# Access Compliance Report

## Public Rights-of-Way

### (Curb Ramps)

Intersection ID: 14982	Main Street: ARENA_BV	Cross Street: COLISEUM_DR	Location: W
ADA ID: 9EA1653EF54B	Ramp Type: BlendTrans1	Initial Pass/Fail: Fail	Overall Compliance: No
Severity Score: 8.75			
Codes/Mitigation Info/Possible Solution		Field Measurements/Component Compliance

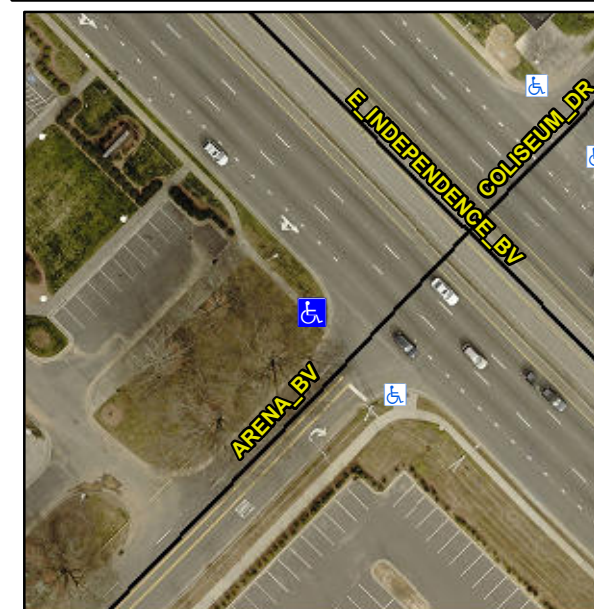
**Not Found, R304.5.1**

Compliance	Description	Data	Compliance	Description	Data
N/A	Ramp Length (in)	50.5	Yes	BlendTrans Slope (%)	3.3
No	Ramp Width (in)	47.5	Yes	BlendTrans XSlope (%)	0.2
N/A	Flare Type LT	N/A	N/A	Flare Type RT	N/A
N/A	Flare Slope LT (%)	N/A	N/A	Flare Slope RT (%)	N/A
N/A	Flare Traversable LT?	N/A	N/A	Flare Traversable RT?	N/A
N/A	Landing Length (in)	N/A	N/A	DWS Provided?	N/A
N/A	Landing Width (in)	N/A	N/A	DWS Contrast?	N/A
N/A	Landing Slope (%)	N/A	N/A	DWS Length (in)	N/A
N/A	Landing X Slope (%)	N/A	N/A	DWS Full Width?	N/A
N/A	Landing Curb? (Y/N)	N/A	N/A	DWS Offset (in)	N/A
N/A	Shared Landing?	N/A			
N/A	Gutter Ponding?	N/A	N/A	Gutter Slope (%)	N/A
N/A	Gutter Lip Ht (in)	N/A	N/A	Gutter X Slope (%)	N/A
N/A	Painted X Walk1?	No	N/A	Painted X Walk2?	N/A
	X Walk 1 Direction	To SE		X Walk 2 Direction	N/A
	X Walk 1 Width (in)	N/A		X Walk 2 Width (in)	N/A
	X Walk 1 Slope (%)	4.2		X Walk 2 Slope (%)	N/A
	X Walk 1 X Slope (%)	1.1		X Walk 2 X Slope (%)	N/A

N/A	Ramp inside XWalk1?	N/A	N/A	Ramp inside XWalk2?	N/A
	Road Slope (%)	1.1		Clear Space?	N/A
	Road X Slope (%)	4.2	N/A	Clear Space to XWalk (in)	N/A
N/A	Any Obstructions?	N/A	N/A	Storm Grate/Utility Hazard?	N/A
	Obstruction Type			Storm Grate/Utility Type	
		N/A			N/A
			Yes	Surface Condition? (G/P)	Good
			No	Curb Slope (%)	14.7

**Remove & Replace Curb Ramp With Two New Directional Ramps or Equivalent.**
